Technical Note

Project:	Adamstown Station Phase 3 - Block ACD		
Subject:	Block ACD - Roads and Transport RFI response		
Author:	Peter Foley		
Date:	08/09/2022	Project No.:	5150924
Atkins No.:	5150924DG0112		
Distribution:	SDCC and Design Team

1. Adamstown Station Phase 3 Block ACD

Figure 1: Currently proposed and previously submitted footpath on West Street.

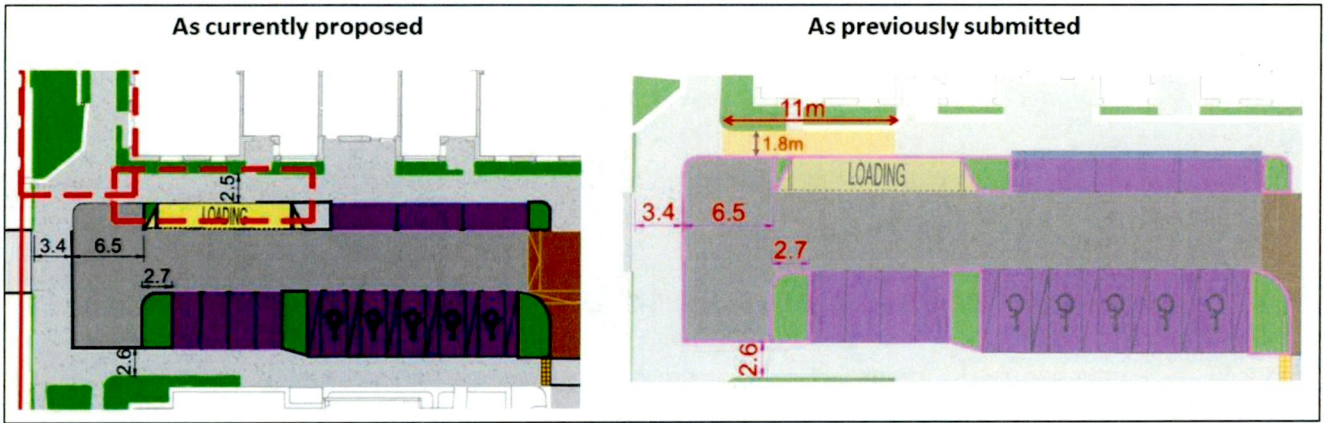
“The applicant is requested to submit a revised layout not less than 1:200 scale showing the minimum width of footpaths at 2.0m wide.”

All footpaths within the demise of the application are a minimum of 2m. Please refer to drawing 5150924-HTR-08-DR-0101 Rev C for details.

On the previously submitted Block ACD application on a small section of West Street the footpath was reduced to 1.8m to provide defensible space to a ground floor residential unit. This has been revised for the current submission. The previously submitted and currently proposed images are shown in Figure 1 for ease of reference.

Figure 3: Internal changes to undercroft to incorporate improved access to parking

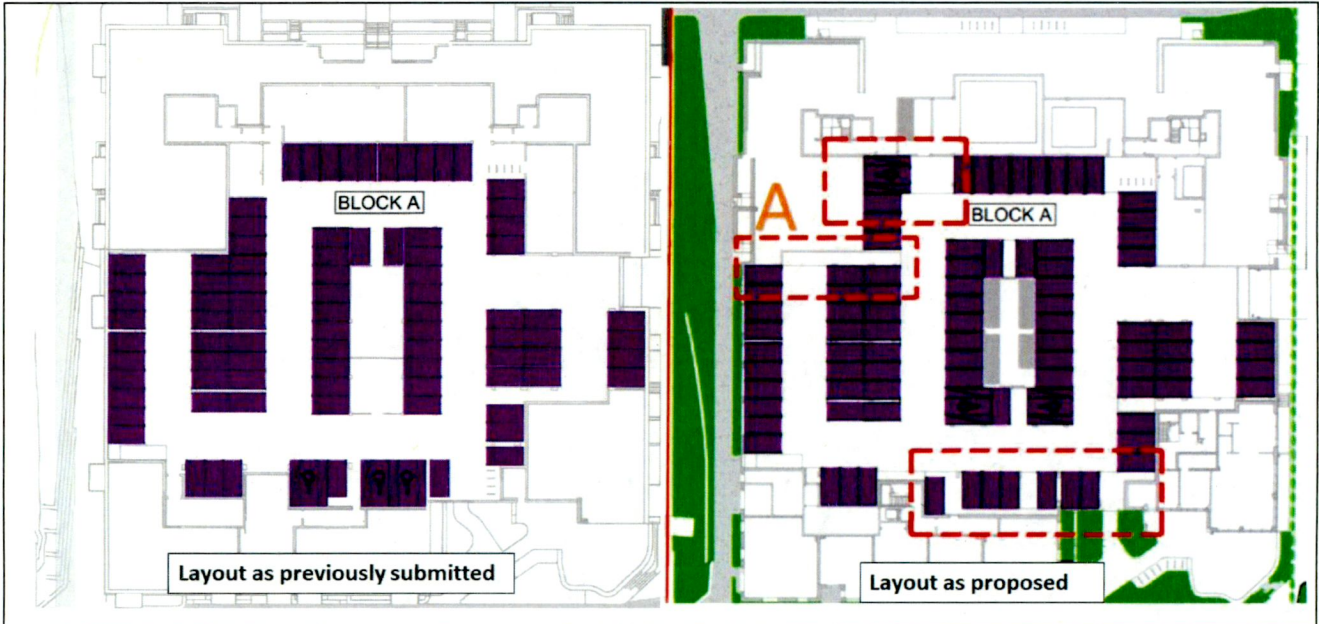
"The applicant is requested to submit a revised layout not less than 1:200 scale showing a turning location at the dead end in the car park of Block A, as per road safety audit."

The internal layout of the undercroft has been amended as part of the RFI response as shown in Atkins drawing 5150924-HTR-08-DR-0101 Rev C. The changes between the submitted and now proposed are highlighted in Atkins drawing 5150924-HTR-08-SK-0047, an extract of which is shown in Figure 3. This includes a corridor behind the dead-end area (see A on Figure 3) that facilitates additional space to allow cars to manoeuvre into and out of these spaces. Atkins drawing 5150924-HTR-08-SK-046 shows vehicle tracking that shows these end spaces are accessible.

Figure 4: Crossing facilities on West Street

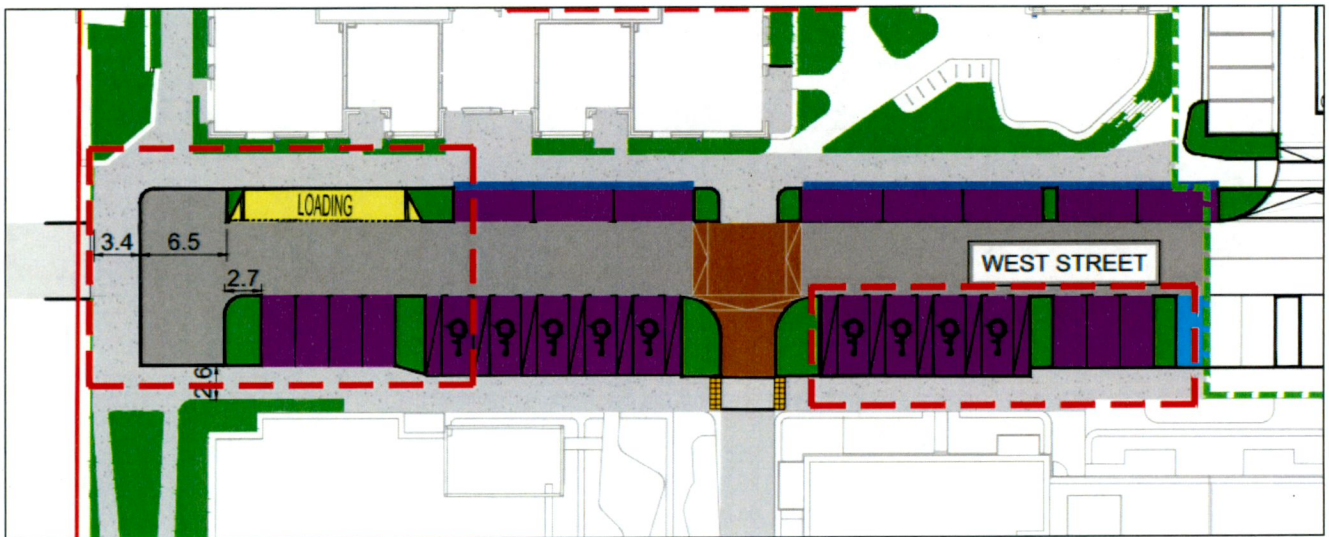
“The applicant is requested to submit a revised layout not less than 1:200 scale showing pedestrian crossing locations along the West Street, as per road safety audit.”

Atkins road and transport layout drawing 5150924-HTR-08-DR-0101 Rev C shows revision to West Street to provide enhanced pedestrian facilities along the western boundary adjacent to the Farmers Bridge. The turning head has been adjusted eastwards to provide a wider pedestrian path. Central location on West Street is a raised crossing that provides a clearly defined crossing picking up on the desire line between Block C & D. To the east of west street, the north-south pedestrian desire line and associate crossing facilities has been provided as part of previous granted planning permission for Block B&E. Figure 4 shows an extract of the crossing provided.

Figure 6: Visitor set down parking spaces on Station Road.

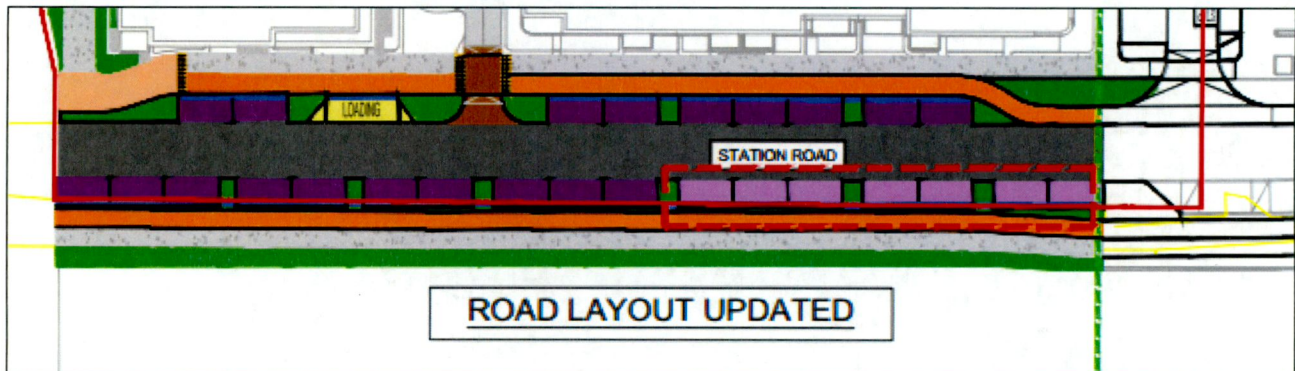
"The applicant is requested to submit a revised layout not less than 1:200 showing 7no. assigned car parking spaces on the south side of the Adamstown station Road as unassigned set-down parking spaces for use at the train station."

Atkins drawing 5150924-HTR-08-DR-0101 Rev C shows revision 7no. car parking spaces on Station Road as set-down parking spaces for use at the train station. An extract is shown in Figure 6.

Figure 7: Overview of cycle infrastructure on Station Tile

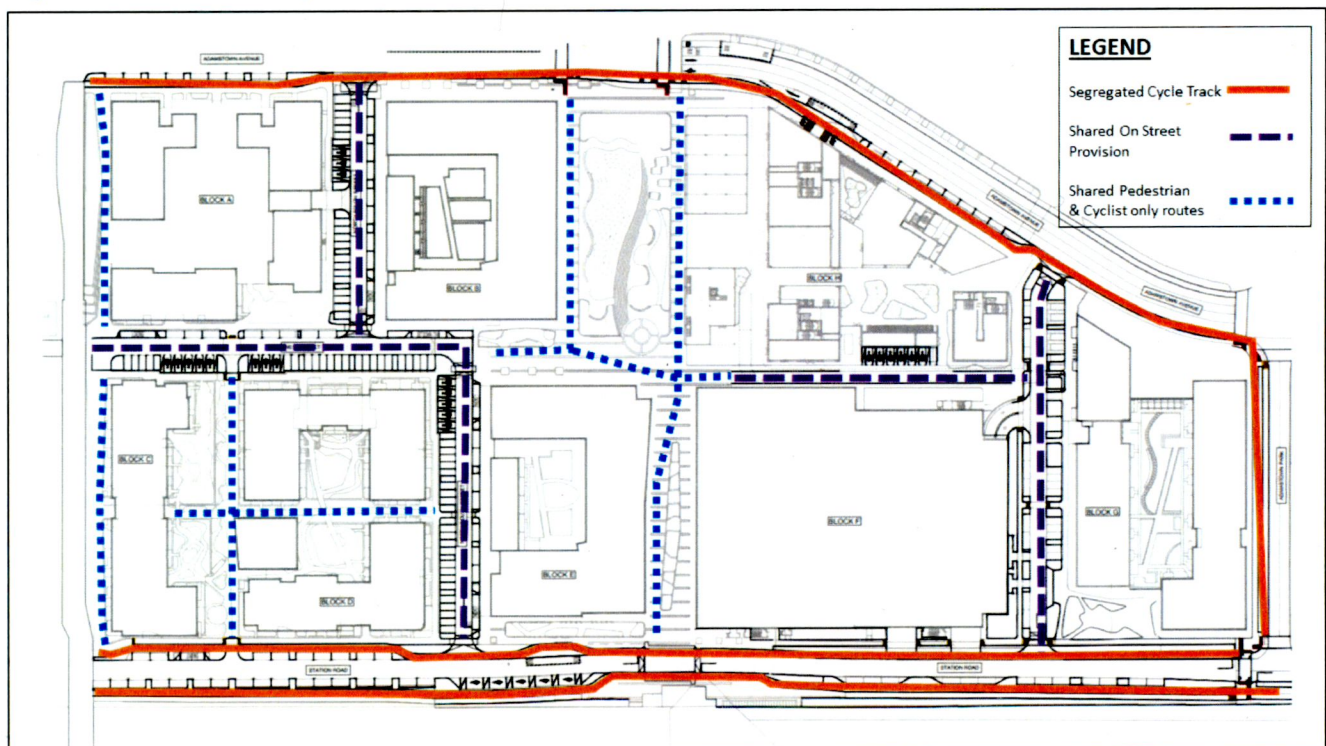
"The applicant is requested to provide details of how the cycle lanes are compliant with the NTA cycle design guide."

On Avenues within the planning application, (sections of Station Road and Adamstown Avenue), that is higher order functional roads with higher volumes of traffic fully segregated cycle lanes have been provided. The design of these segregated cycle lanes is identical to the previous phase for the Station Tile including the agreed approach along Station Road which was agreed with the National Transport Authority (NTA). While on quieter roads such as West Street the design approach is that cycle facilities are provided in a shared on street provision. In addition to the above there are areas within ACD, such as along Famers Bridge, between block C&D where there is shared pedestrian and cycle routes only. This approach is shown in Figure 7 an extract from the Transport Statement submitted as part of the planning application.

This approach is consistent with National Cycle Manual Section 1.7 Integration and Segregation.

Figure 9: Bus set down and turning areas provided on Station Road on Boulevard Tile

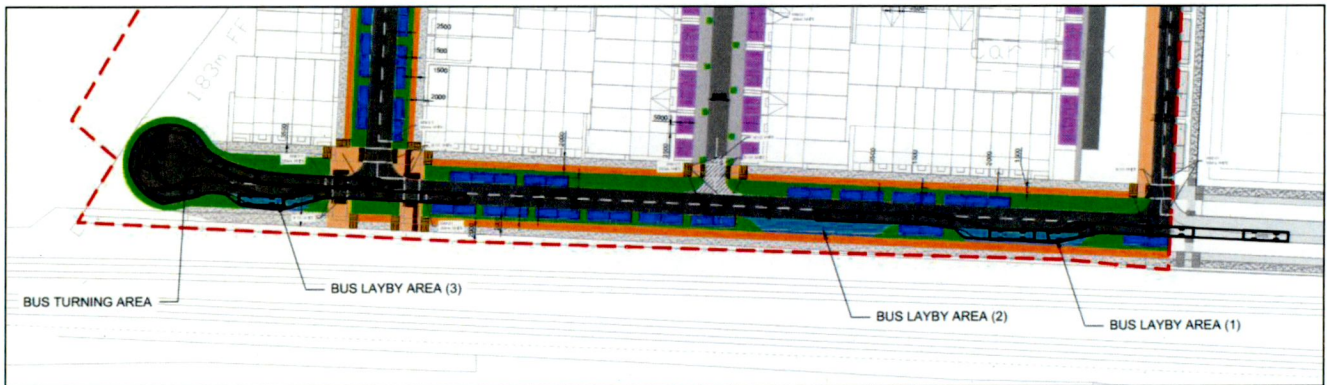
“The applicant is requested to provide details of bus set down areas.”

Bus set down areas and bus turning areas are provided on Station Road on the adjoining Boulevard Tile. Atkins drawing 5150924-HTR-10-DR-0129 submitted as part of the planning application (Ref SDZ22A/0007) for Adamstown Boulevard Phase 1 to South Dublin County Council (SDCC) shows the location of the set down and turning facilities. An extract of this drawing is shown in Figure 9 and a copy of the drawing has been submitted as part of this RFI for information. The 3No. laybys provide capacity for 5 No. buses to set down. This approach was discussed and agreed with SDCC (Roads) and the NTA during formal pre-application discussion for Boulevard Masterplan and Phase1 planning application.
